UNION ELECTRIC COMPANY

ULNRC-792

DOCKET NUMBER 50-483  
CALLAWAY PLANT, UNIT 1  
CALLAWAY TECHNICAL SPECIFICATIONS

- Attachments: 1) Summary Listing of Attached  
Specifications  
2) Specifications Resolved Since  
Final Draft  
3) Specifications Being Appealed  
4) Specifications Which Have Not  
Been Resolved

FIGURE 3.2-3

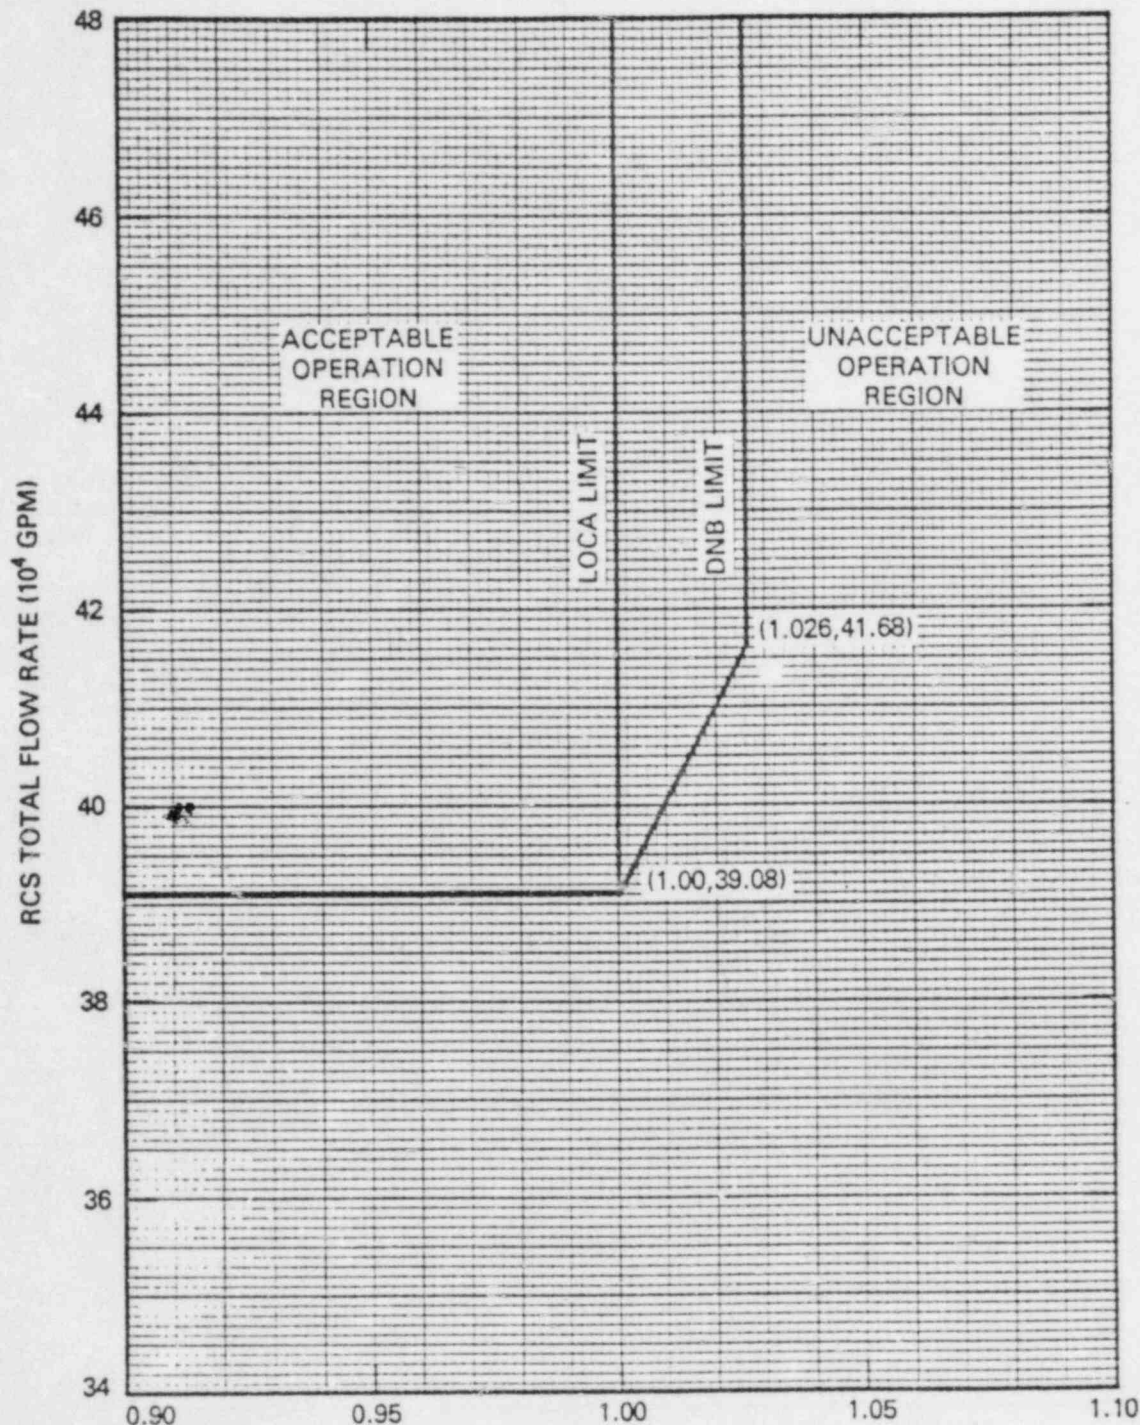
c.  $F_{\Delta H}^N$  = Measured values of  $F_{\Delta H}^N$  obtained by using the movable incore detectors to obtain a power distribution map. The measured values of  $F_{\Delta H}^N$  shall be used to calculate R since Figure 3.2-3 includes penalties for ~~undetected feedwater venturi fouling of 0.1% and for measurement uncertainties of 1.0% for flow and 4% for incore measurement of  $F_{\Delta H}^N$~~

PENALTIES OF 0.1% FOR UNDETECTED FEEDWATER  
~~VENTURI FOULING AND~~ MEASUREMENT UNCERTAINTIES OF 2.0% FOR  
 FLOW AND 4.0% FOR INCORE MEASUREMENT OF  $F_{\Delta H}^N$  ARE INCLUDED  
 IN THIS FIGURE
